# CITY OF PORTLAND, MAINE

Project Name:	Nineteen-Unit Condominium	Project ID:	2017-073, 2017-115
Address:	155 Sheridan	CBL:	012 Q012
Applicant:	Bernie Saulnier		
Planner:	Matthew Grooms

RE: Staff Review Comments for 155 Sheridan Street (2017-073) – Planning Board Review

Level III Site Plan and Subdivision Plan and Conditional Use Application for Inclusionary Zoning

Figure 3: Proposed Overhead Configuration

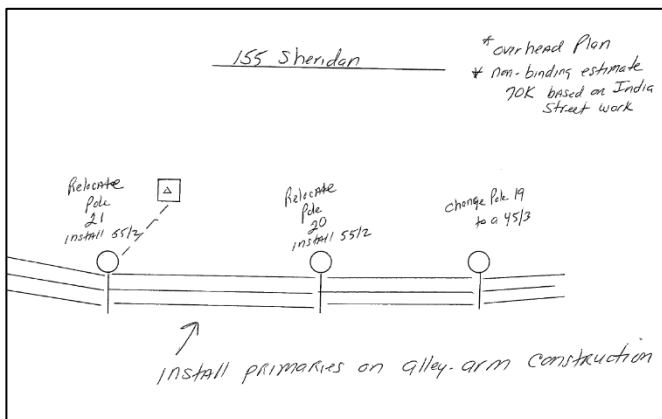
According to Mr. Duperre, the cost of an overhead configuration with raised poles and alley arms would likely be around \$70,000, based upon a similar configuration installed on India Street. This proposal would involve relocating poles 20 and 21 away from the proposed building’s frontage and raising the poles approximately seven feet in elevation. The non-binding estimate for the underground configuration would be between \$120,000 and \$140,000. This proposal would involve relocation of pole 21 from the east side of Sheridan Street to the west side, and removal of existing poles 20 and 22, currently along the building’s frontage and to the north of the project site, with the installation of two underground vaults along the property’s frontage. This proposal would involve work to be completed within Sheridan Street (*Plans 31 and 32*).

The overhead configuration is considered acceptable though not preferable from a life/safety perspective and would meet fire department standards for building access. Keith Gautreau, Assistant Fire Chief, has indicated his preference to see the lines installed underground. This consideration is being addressed as a waiver request, and is further being reviewed as a condition for approval, subject to the final cost estimate provided by CMP.

Figure 4: Proposed Underground Configuration

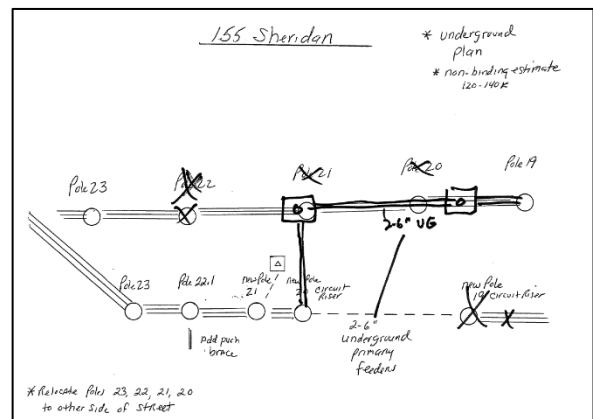
In response to preliminary plan review comments from Planning, the Department of Public Works and Fire Department requesting that utility lines be placed underground, the applicant met with and discussed cost estimates with Central Maine Power for the placement of electrical service lines underground. It was initially determined to be cost prohibitive, which prompted the developer to pursue an alternative option in which the lines would be located on elevated poles and moved away from the building by means of alley arms. Given that this alternative does not

meet city standards as stated above and is not a preferred alternative for the fire department, city staff have solicited additional information to inform the recommendation to the Planning Board.
